**CHANGE ORDER**  
City Of Angels

CHANGE ORDER NO. 001	CONTRACT NUMBER	PROJECT Booster Way Sewer Replacement Project	FEDERAL NUMBER(S)
-------------------------	-----------------	--	-------------------

BOOSTER WAY SEWER, MH 43 TO MH 44-A-1,  
PLAN AND PROFILE

C1.03

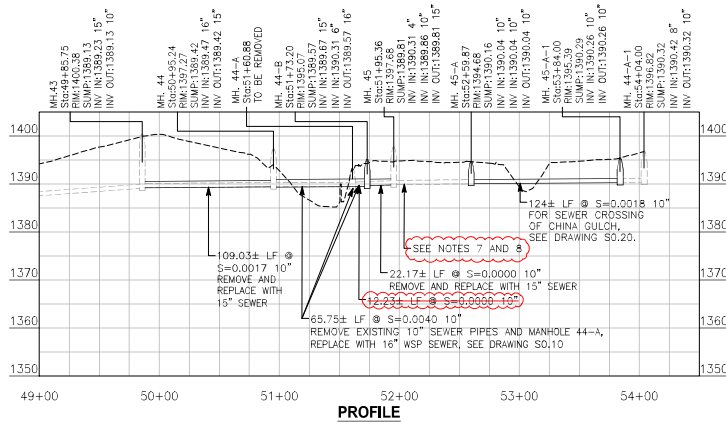
As shown in the attached drawing, Contractor shall complete the following tasks:

1. Remove existing 10" ACP sewer between MH 45 and MH 45-A and dispose of offsite.
2. Remove existing MH 45.
3. Furnish and install 10" DIP sewer between MH 45 and MH 45-A including testing per City standards.
4. Replace MH 45 per City Standards.
5. Restore pavement per City Standards.

- NOTES:**
- FOR SADDLE MANHOLE, SEE DETAIL 3, DRAWING C0.02.
  - FOR DEMOLITION REQUIREMENTS BETWEEN MH. 43 - MH. 45, SEE DRAWING C1.01.
  - FOR IMPROVEMENTS BETWEEN MH. 44 AND MH. 45, SEE PROPOSED SEWER IMPROVEMENTS ENLARGED PLAN, DRAWING C1.04.
  - CONTRACTOR SHALL REMOVE EXISTING SEWER AND MANHOLES WHERE SHOWN WITHOUT CONSTRUCTION EQUIPMENT WITHIN EXCLUSION ZONE. CONSTRUCTION EQUIPMENT MAY BE LOCATED ON BRIDGE TO FACILITATE SEWER AND MANHOLE REMOVAL, SEE DRAWING G0.60.
  - REMOVE 4-INCH UWPA SEWER LATERALS AND RE-CONSTRUCT AS SHOWN ON DRAWING C1.05.
  - REMOVE AND REPLACE MH 45 WITH MANHOLE PER CITY STANDARD DRAWING SS-1.
  - REMOVE 10" ACP SEWER AND REPLACE WITH 10" DIP SEWER.

**CCO#1, 7,31,24**

DATE PLOTTED => AUG 01, 2024  
 TIME PLOTTED => 10:27 PM  
 C1.04

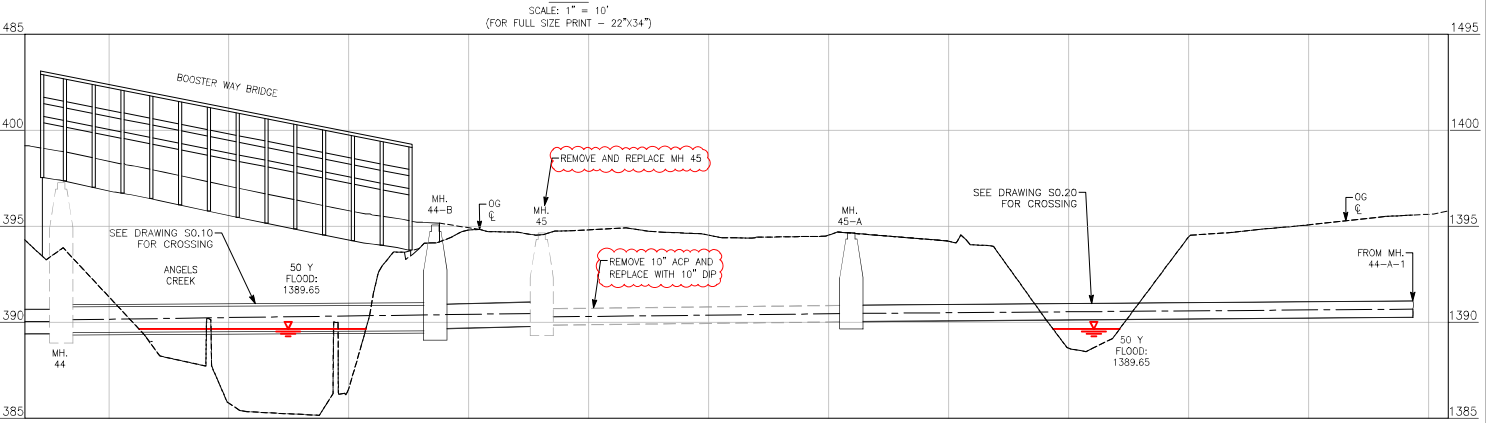
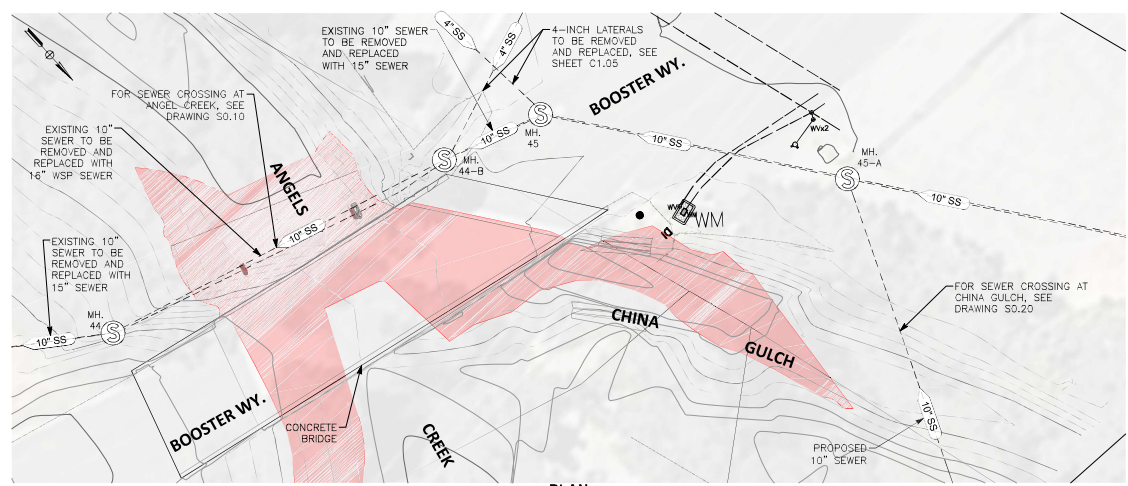
CCO#1, 7.31.24	PROJECT NUMBER & PHASE	0000000001
----------------	------------------------	------------
